DOCKETED	
Docket Number:	25-BSTD-03
Project Title:	2028 Energy Code Pre-Rulemaking.
TN #:	270365
Document Title:	Charlie Stephens Comments - Comment on Part 6 CASE Report Air Distribution, Section 3 (Modulating DPAS)
Description:	N/A
Filer:	System
Organization:	Charlie Stephens
Submitter Role:	Public
Submission Date:	5/29/2026 5:43:01 PM
Docketed Date:	6/1/2026

**Comment on Part 6 CASE Report Air Distribution, Section 3
(Modulating DPAS)**

RE: Comment on 2028 Title 24, Part 6 Draft CASE Report: HVAC Air Distribution, Section 3 (Modulating DOAS)

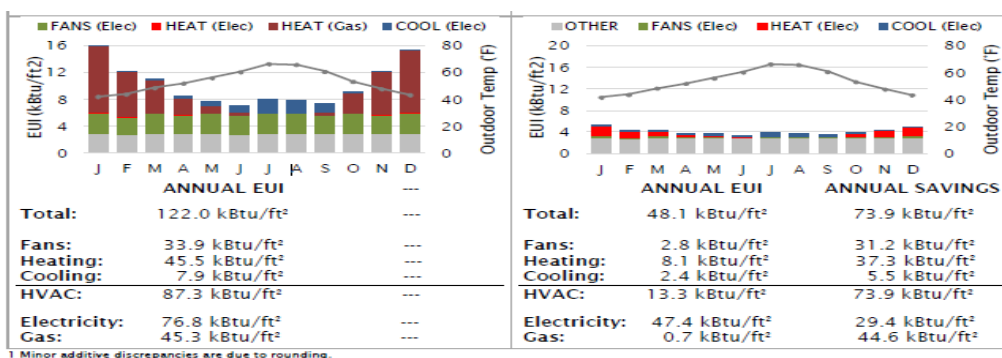
The mandatory requirement for pressure-independent air valves with airflow monitoring stations at every zone is a significant hardware mandate. At full occupancy and typically two-thirds of full rated flow, the H/ERV technologies we're using have cooling Seasonal COPs between 5.5 (hot humid climate) and 10 (marine climate) and heating Seasonal COPs between 8 (hot humid climate) and 12 (marine climate), tested and rated using CSA SPE18-2024. With these equipment efficiencies, managing air flow rates at the ventilation sub-zone level will deliver trivial energy savings and in no way would be cost-effective. Energy savings models must use a workaround because the compliance software cannot simulate the proposed system directly. Fan power baselines and assumptions do not reflect the HRV-DOAS systems that dominate California new construction in dry climates. Field research at California DOAS sites also found per-zone DCV on DOAS was not cost-effective. Below are the results from one of my pilot projects – note the change in fan power, which the models did not predict.
